**Finance and Performance Committee**  
**ATTACHMENTS - UNDER SEPARATE COVER**

<b>TABLE OF CONTENTS</b>	<b>PAGE</b>
<b>10. Hearings Panel report to the Council on the Te Kaha Surrounding Streets</b>	
A. TG145801 Te Kaha - Plans for Approval.....	3
B. Option 1 - Lichfield Street Te Kaha Improvements For Council Approval.....	11
C. Option 3- Lichfield Street Te Kaha Street Improvements For Council Approval .....	12
D. Te Kaha Hearings Panelists Queries and Staff Responses.....	13
E. Te Kaha Event Management Plan - Abley Report .....	49
F. 2022 Revised Scheme Safety Audit Report Te Kaha Surrounding Streets.....	102
G. 2023 Lichfield Street Safety Audit Report.....	180

**DRAFT TE KAHA ADJACENT STREETS HEARINGS PANEL – QUESTIONS AND RESPONSES**

Figure 2-4: Proposed cycle parking across the Madras Street heavy vehicle accessway.

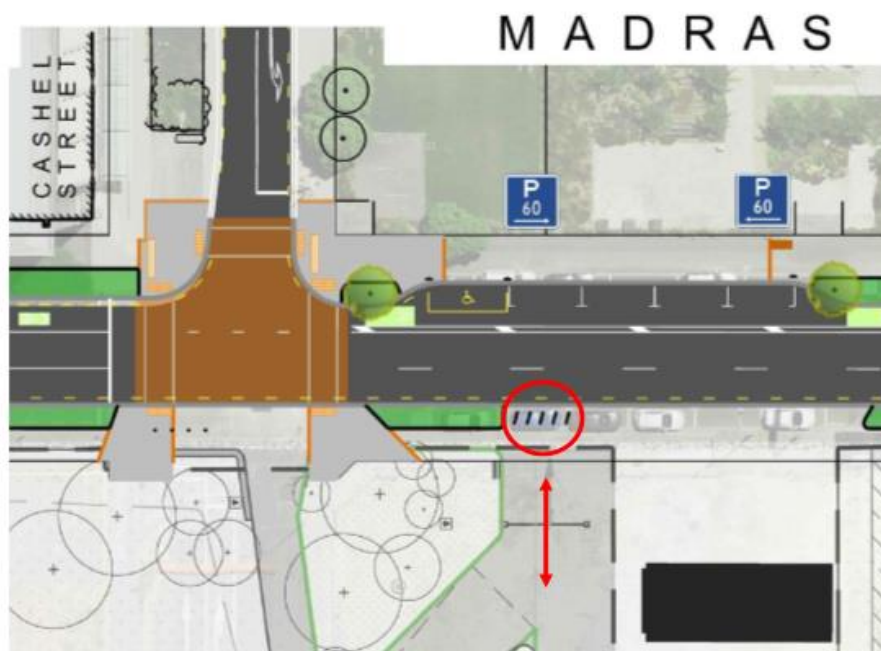
There are a number of practicality and safety issues associated with the proposed on-street cycle parking, proposed to be placed around the CMUA site between the footpaths and carriageways. The SAT appreciates the need for cycle-parking near the entrances and exits, however it is likely that the proposed cycle stands will lead to parked cycles encroaching on the footpaths and creating trip hazards for pedestrians. The locations are likely to be inundated with pedestrians exiting from the CMUA at the end of an event and will be challenging for users to access through crowds, and for them to safely depart on their bikes while crowds linger. There is also a stand of cycle parks proposed across the entranceway that is designated for the heavy vehicle access, refer to Figure 2-4.

Figure 2-5: Example of expected pedestrian movements between Madras Street and CMUA Western Plaza

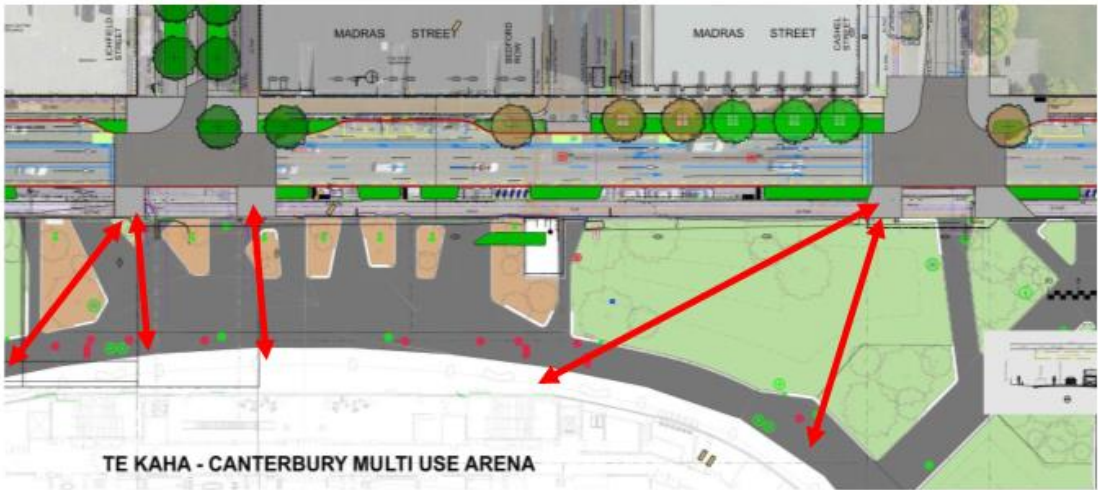
A number of the areas of landscaping are likely to obscure pedestrian desire lines, especially after events when pedestrians will be exiting the arena in large numbers. In several places there is site landscaping and street furniture (bollards, seating, etc) located inside the CMUA boundary that is positioned directly in the way of pedestrian desire lines, and there are landscaping beds proposed in the footpaths directly adjacent to a number of the stadium accessways in several places. These landscaping beds will especially hinder vulnerable users crossing at intersections either heading towards or away from the facility, and will also pose trip hazards to able-bodied pedestrians. Unexpected changes to surface texture or landscaping bed established at different levels to the surrounding footpaths can pose trip hazards to pedestrians, which have especially severe outcomes for vulnerable users. Figure 2-5 demonstrates the expected pedestrian movements between the Madras Street on-street frontage and the CMUA western plaza.

Figure 2-6: Scheme Design Drawings – Barbadoes /Cashel Intersection

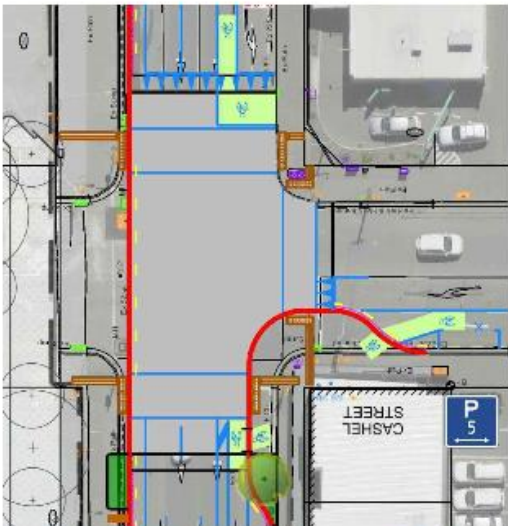
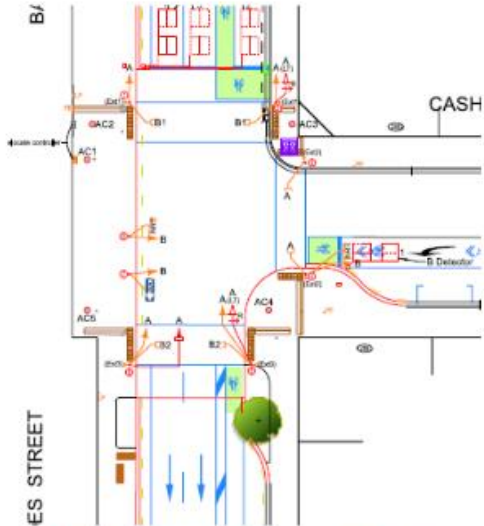
A review of the Traffic Signal plans revealed an inconsistency between the overall scheme design drawings and the traffic signal drawings, namely at the Barbadoes / Cashel intersection. A snapshot of both drawings is below which shows the cyclists being directed off the Cashel Street approach into the widened shared area in the scheme drawings while the cyclists are to remain in the on-street lane in the traffic signals drawings.

Figure 3-1: Cyclists crossing onto St Asaph Street from High Street will conflict with pedestrians waiting to cross St Asaph Street.

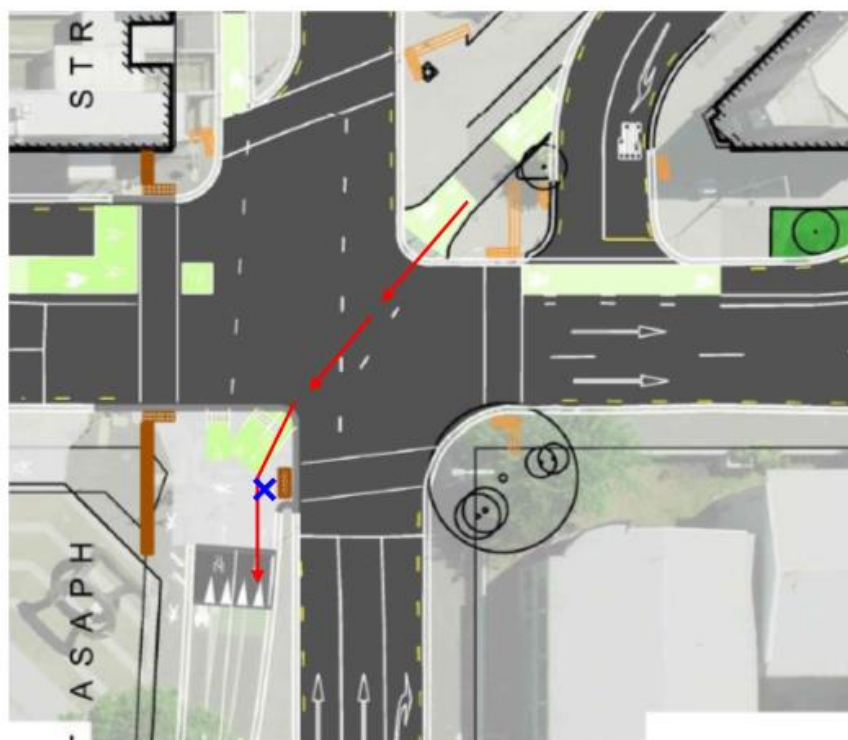
The south-eastern quadrant of the intersection is proposed to be designated as a shared space, but the cycle desire lines will directly conflict with pedestrians waiting to cross St Asaph Street. Pedestrians wishing to cross St Asaph Street to travel north will need to wait in the path of all the cycle movements originating from High Street. The SAT observed on site that when Ara students are leaving the campus, there can be groups of pedestrians at any one time using this intersection and there is potential for the pedestrians to block the path for cyclists under this arrangement.

Figure 3-2: Long directional pavers, omitted direction pavers, and conflict between cycle desire lines at the interface of the cycleway and shared pathway area in the St Asaph/Madras intersection.

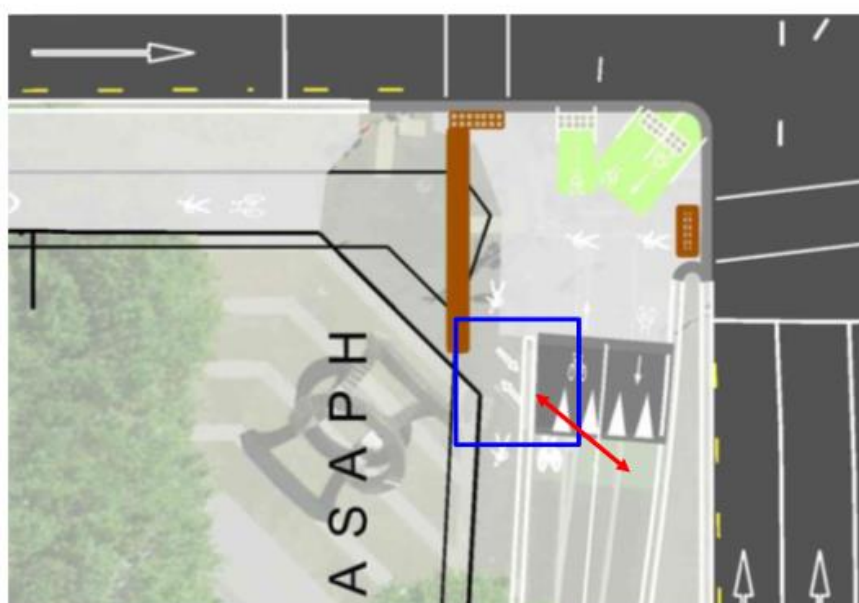
No improvements are proposed for the north-eastern quadrant of the intersection where the footpath widths are constrained between the adjacent student accommodation buildings and fences and the carriageway. Since the eastern side of Madras Street to the south is to be converted to a shared path, there is a risk of cyclists continuing north to avoid joining the on-street cycle lane on the western side of Madras Street.

Figure 3-3: Unprotected parking lane on Madras Street with red arrow indicating where the apparent third lane may be misinterpreted

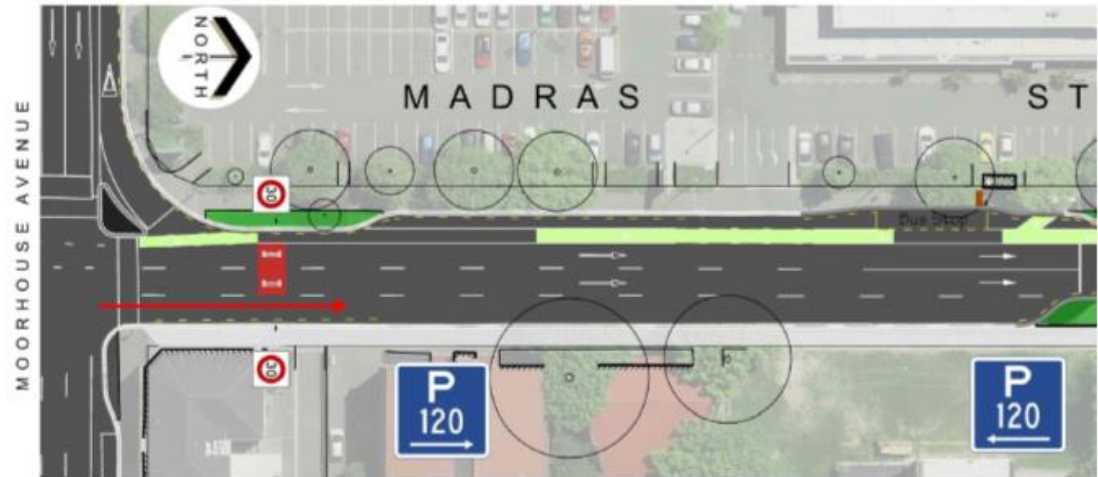
The proposed parking lane at the southern end of the Madras Street improvements is unprotected and the broken white line marking makes the road appear as if it has three traffic lanes rather than the intended two traffic lanes and one parking lane.

Figure 3-4: Departing buses crossing paths with cyclists using the ramp-off to join the signalised crossing

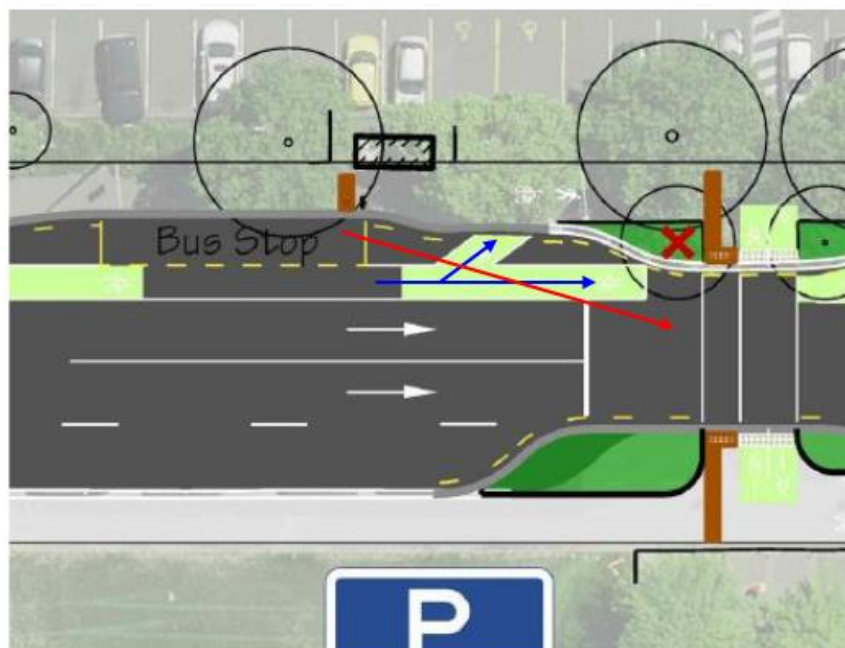
The drawings show some green surfacing for the cycle lane but there are gaps in places including alongside the bus stop which is a key conflict area.

Figure 3-5: Pinch point at the north end of the Broadcasting School building

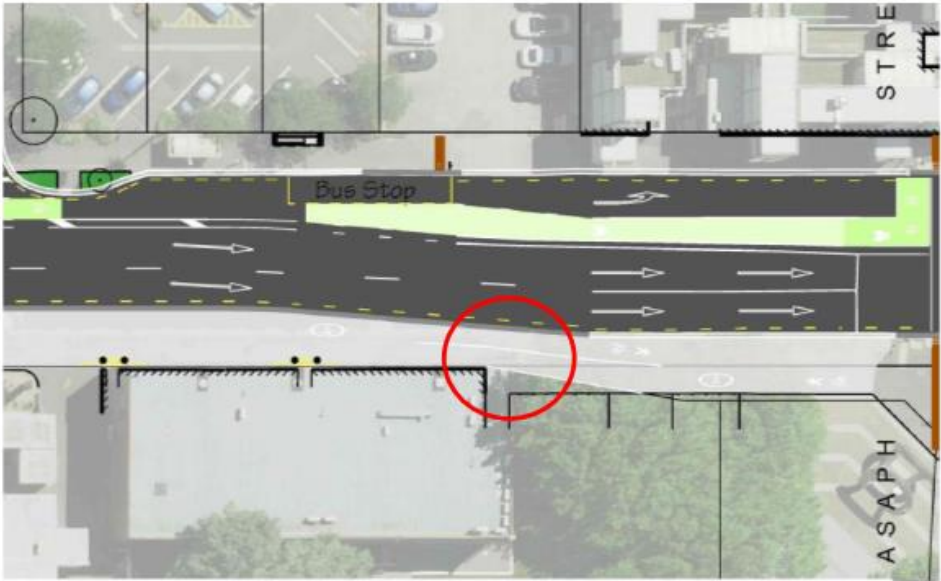
The design includes a centreline and "SLOW" pavement markings at the northern shared path pinch point, however there are no additional aids above pavement level to warn users they are entering a constrained space, and there is increased possibility of collisions between users in the constrained space. There appears to be several services under the existing berm at the very northern end of the proposed shared path. When access restrictions are in place during maintenance and repair works the shared path's capacity will be significantly reduced and this will further exacerbate the risks of conflict between users at this end of the shared path. Consideration will also need to be given to the treatment of the service lids to prevent them becoming trip, slip, and fall hazards when they are included in the shared space surface.

Figure 3-6: Narrow section of shared path with door swing hazard area highlighted

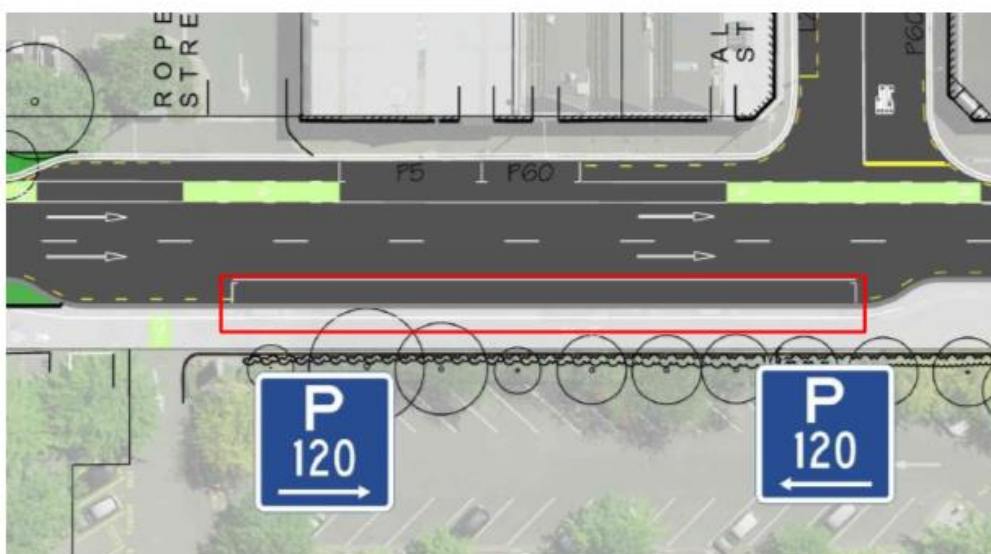
There is on-street parking proposed adjacent to the southern narrow section of shared pathway. As this pathway is adjacent to the right-hand lane of Madras Street, this places the drivers' side of the car against the footpath, and therefore every car which parks in these parks will open their door out across the shared path. This increases the risk to cyclists and micro-mobility users of colliding with opening car doors, which is known to have severe outcomes for especially cyclists, on top of the additional risks associated with using constrained shared spaces.

Figure 3-7: Proposed cycle accessway off Madras Street south of Kotare (The red arrow denotes a tree to be removed)

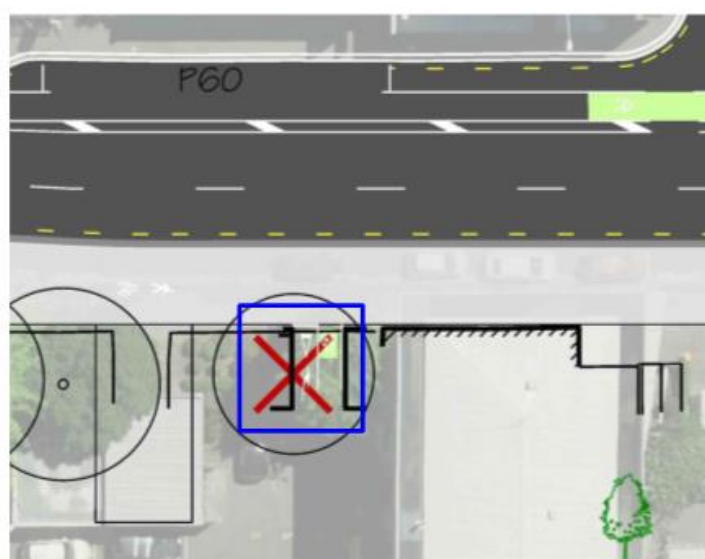
There is a new cycle accessway to Ara proposed between the Kotare Building and the substation, but it is well hidden between both buildings and will be hard for an occasional user of the space to recognise. As visibility of the accessway is poor, it will be hard for users to anticipate other users slowing to turn into or exiting from the accessway, and this will create conflict between users.

Figure 3-8: Possible desire lines for cyclists turning north from the Madras Street shared path

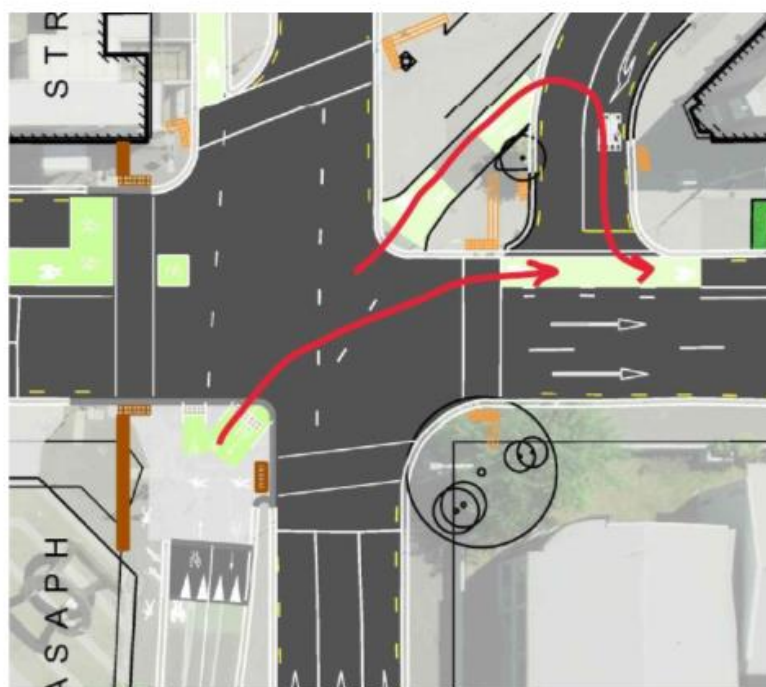
The SAT observed that the cycle provisions are discontinuous between St Asaph and Tuam Streets. The shared path on the eastern side of Madras Street stops at St Asaph Street and cyclists need to cross diagonally to use the on-street cycle lane at Madras Street to continue northbound. However, the diagonal cycle crossing does not connect to the northbound on-road cycle lane on Madras Street so cyclists either need to meander through High Street to return to Madras Street or cut across the High Street intersection which increases the possibility of collisions between cars and cycles.

Figure 4-1: Narrow pedestrian crossings and poorly positioned mobility parking at the Lichfield Street and Cashel Street Intersections

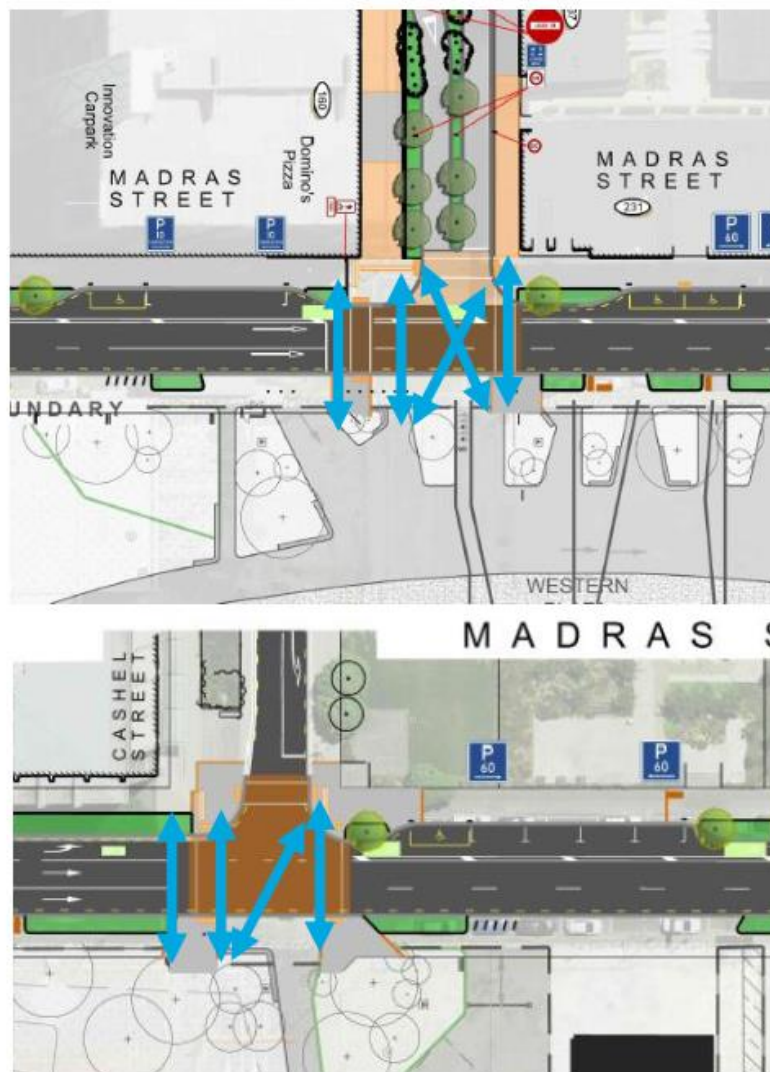
The parking spaces on the western side of Madras Street do not serve any business frontages directly and could easily be sacrificed in favour of wider crossing points and build-outs, additional accessible parking spaces, or P10 for short stay pick-up/drop-off.

Figure 4-2: Tuam Street looking east towards Madras Street, note narrow footpath with hazards

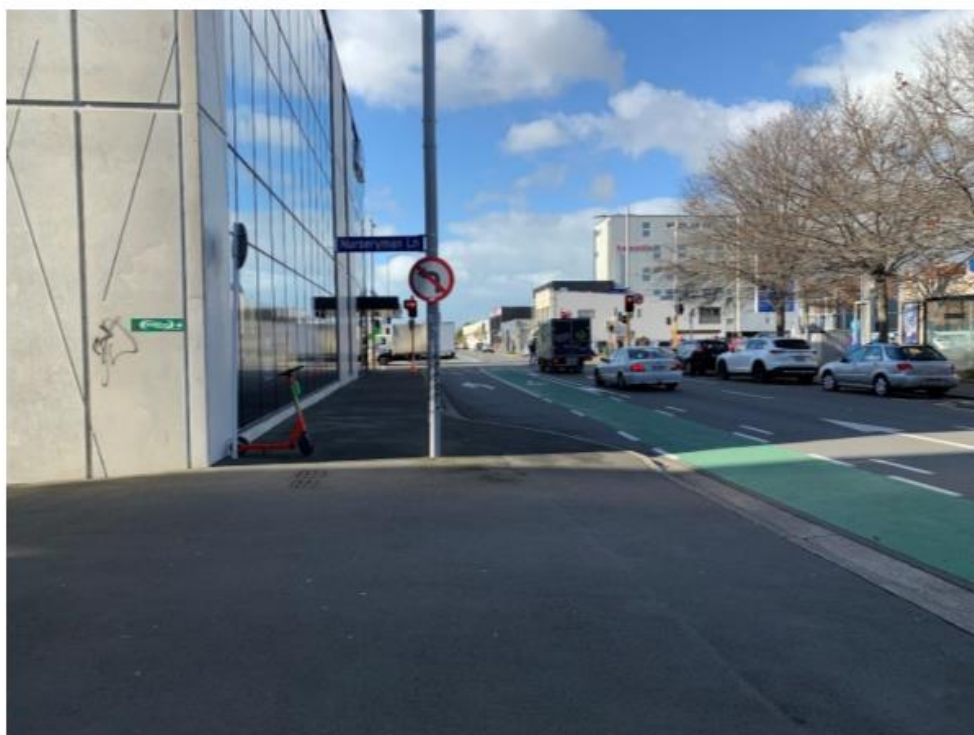
The narrow existing footpaths on the north side of Tuam Street leading west from Madras Street will be inadequate to cater for larger groups of people. Tuam Street is likely to be a secondary but still well-used link between the CMUA, the Bus Interchange and hospitality areas – would benefit from some improvements to improve pedestrian provisions. There is no separation between the footpath and the neighbouring buildings, so the only option for pedestrians to avoid each other in high volume events is to move into the road. Depending on the numbers of people this can create risks of collision with cyclists in the adjacent cycle lane or even vehicles in the traffic lane. The SAT observed street lighting columns and traffic signal poles located within the narrow footpath which will create trip hazards for vulnerable users.

Figure 5-7: Existing access to Waitomo Fuel from Tuam Street

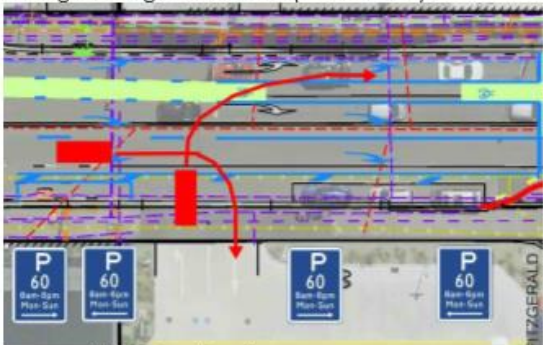
crossing the driveways (particularly where they are walking to and from the CMUA) as the forecourt is on a 45 degree angle and drivers' visibility may be impaired.

Figure 7-1: Potential splitter island to channelise traffic at Lichfield/Madras intersection

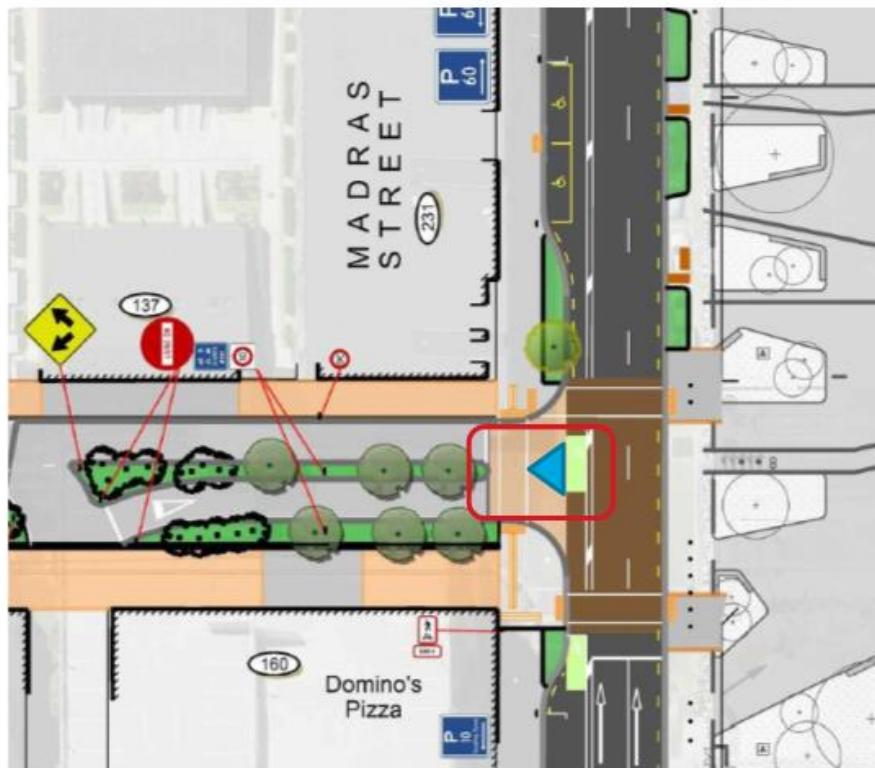
The SAT consider that there is value in by including a central splitter island between the crosswalk and green cycle paint on Madras Street, to channelise the left turn movement from Lichfield Street into Madras Street and to provide additional protection for pedestrians in the intersection.

Figure 7-2: Nurseryman Lane looking north from Tuam Street towards Lichfield Street

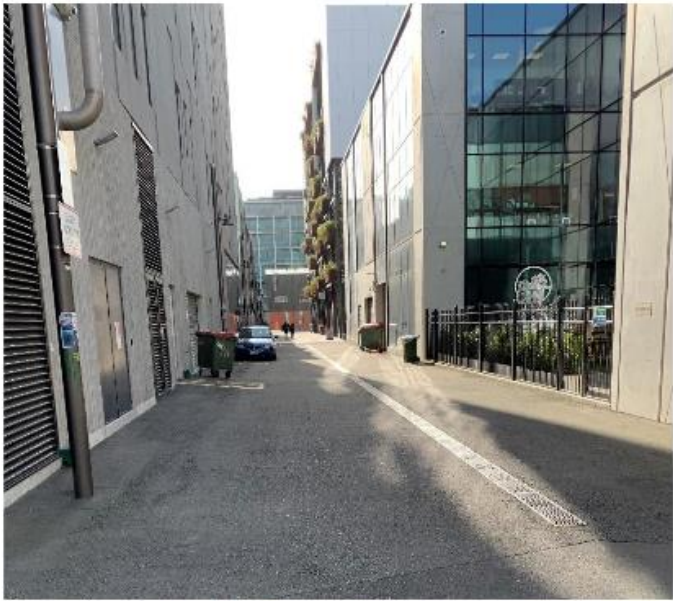
There is a significant risk of conflict between all users in the space if no improvements are made. As can be seen in Figure 7-2 rubbish skips located in the lane together with parked vehicles. This may create conflicts with vehicles, and in turn with pedestrians, cyclists, and micro-mobility users if the trafficable width is constrained or blocked.
